Addendum #3

There are a few questions or comments regarding Addendum #2 for the Nursing Simulation Center project.

SCALE: 1:1
ALL RIGHTS RESERVED
SHEET NO.: TA101

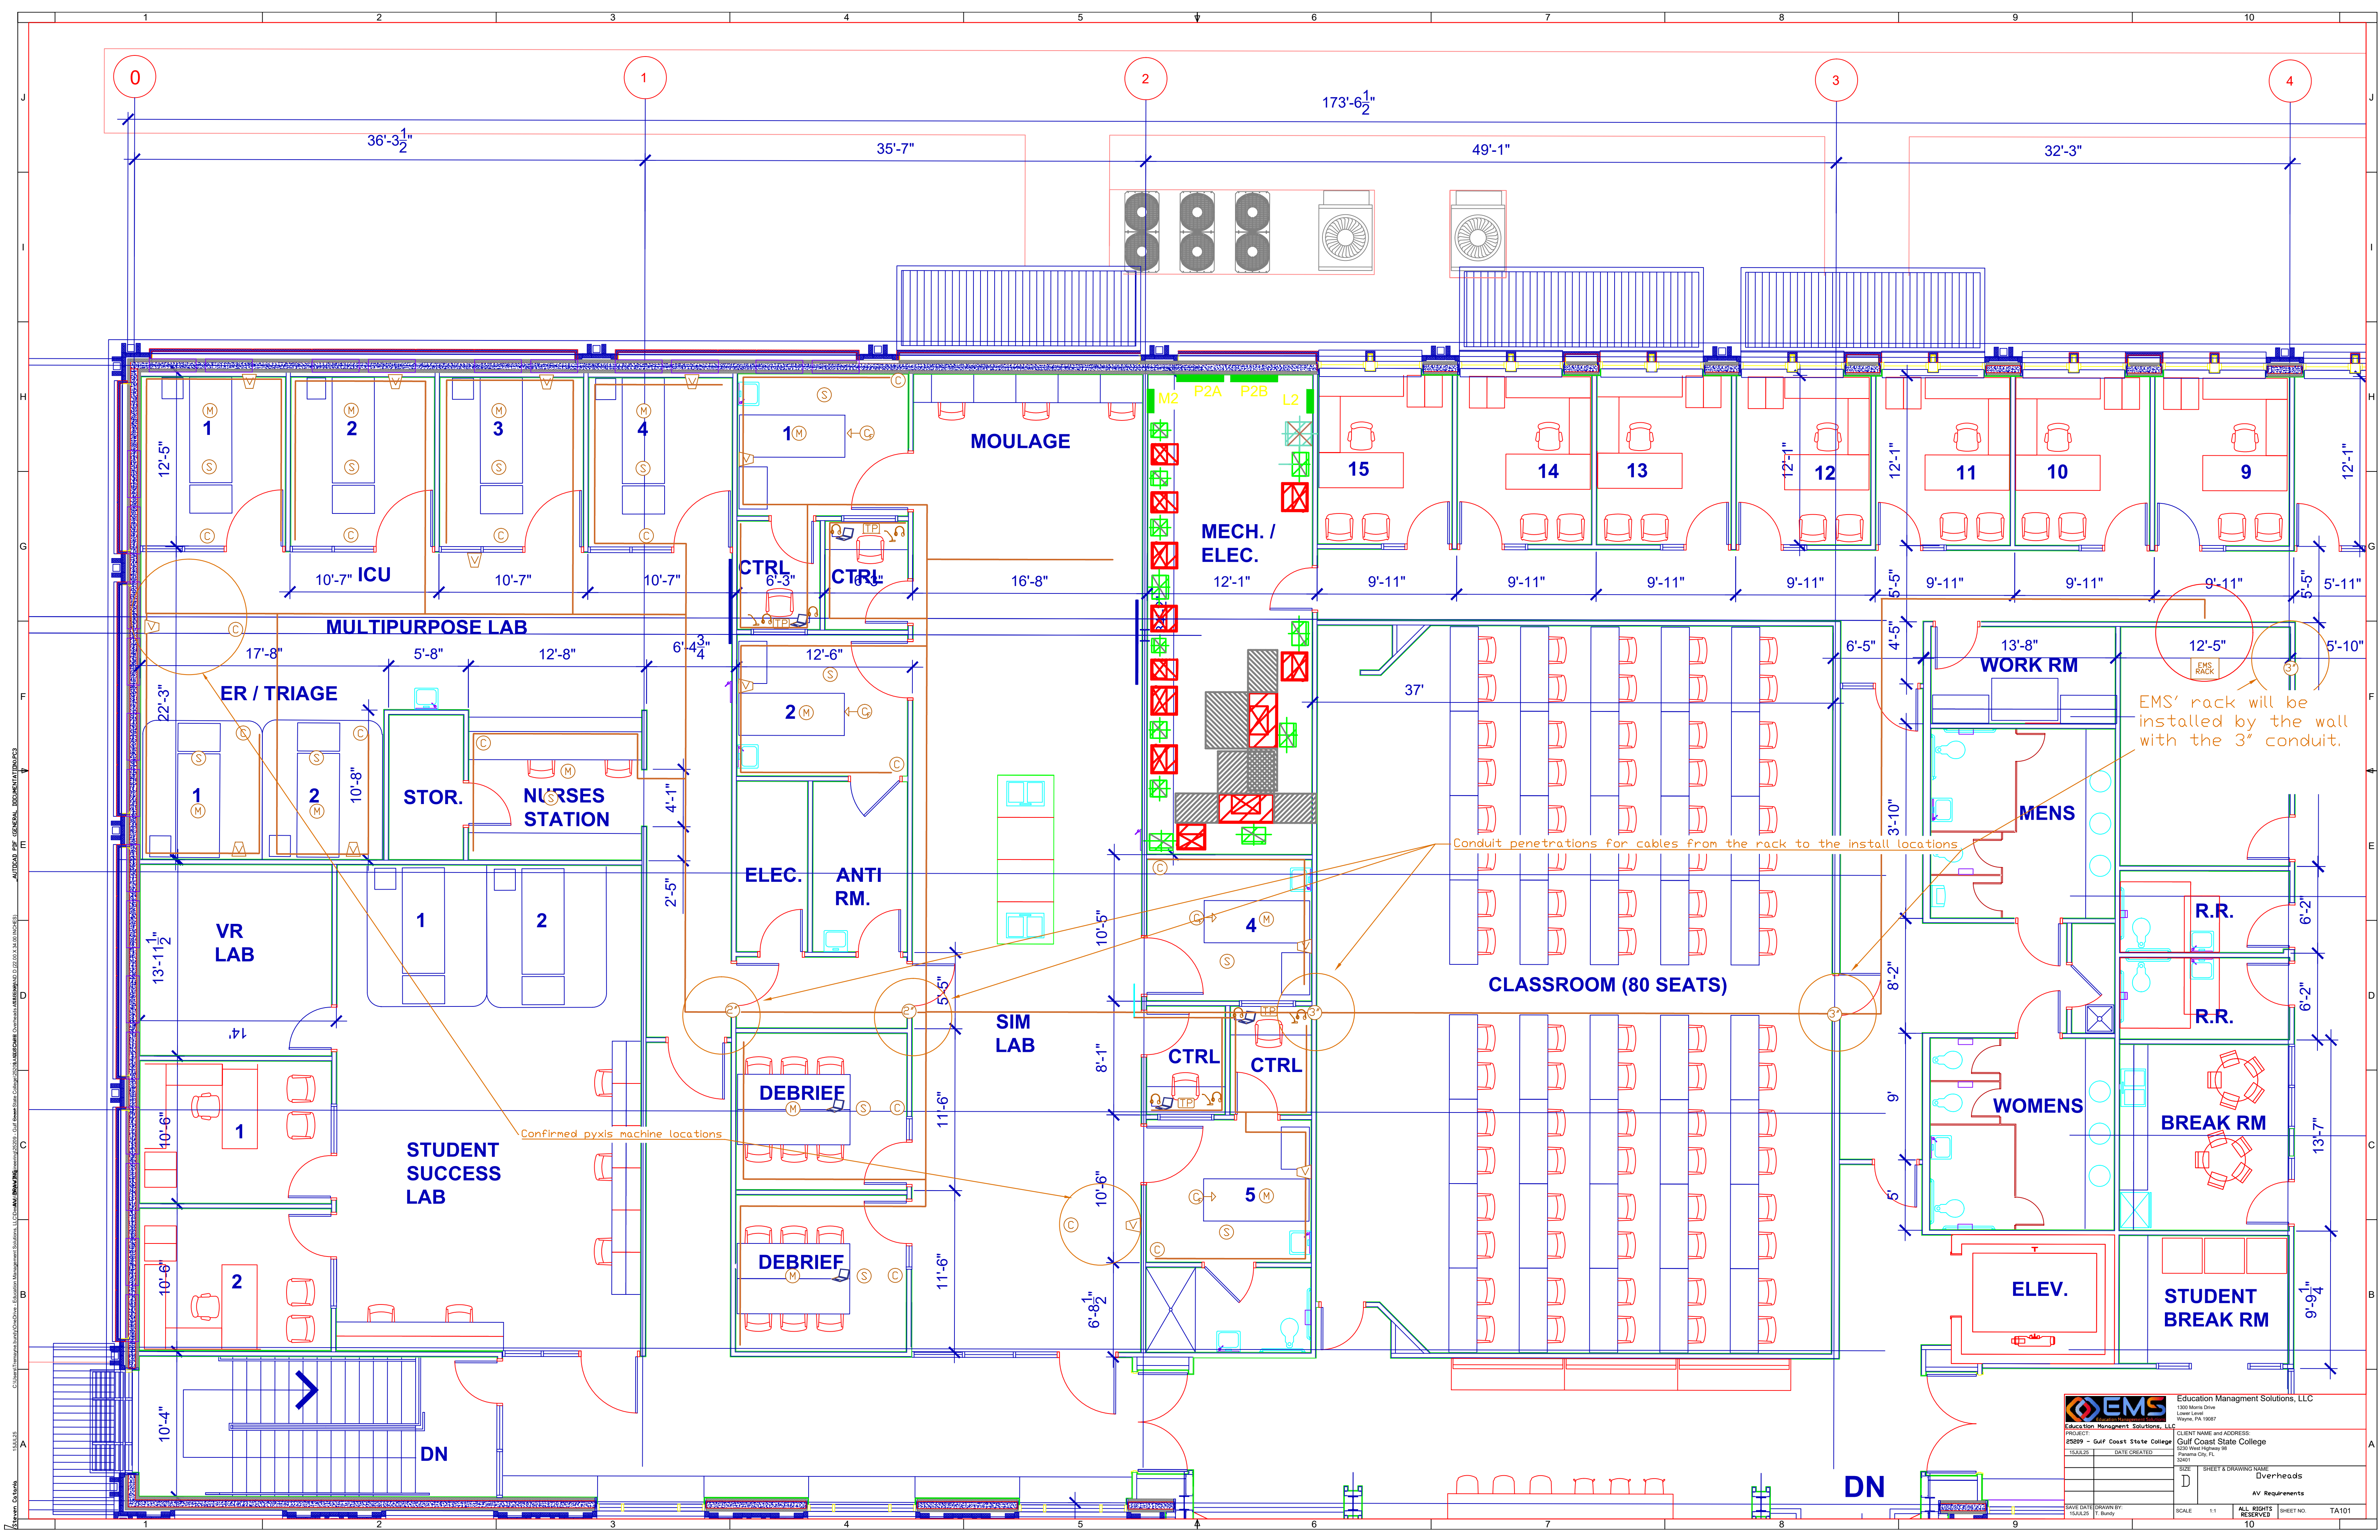
We'd like to include the EMS vendor drawing package as an attachment to the next Addendum. They are for reference only as the only required information for the bidding contractors is already addressed by the electrical engineers and included in their drawings; this is strictly a coordination effort. **SEE ATTACHED**
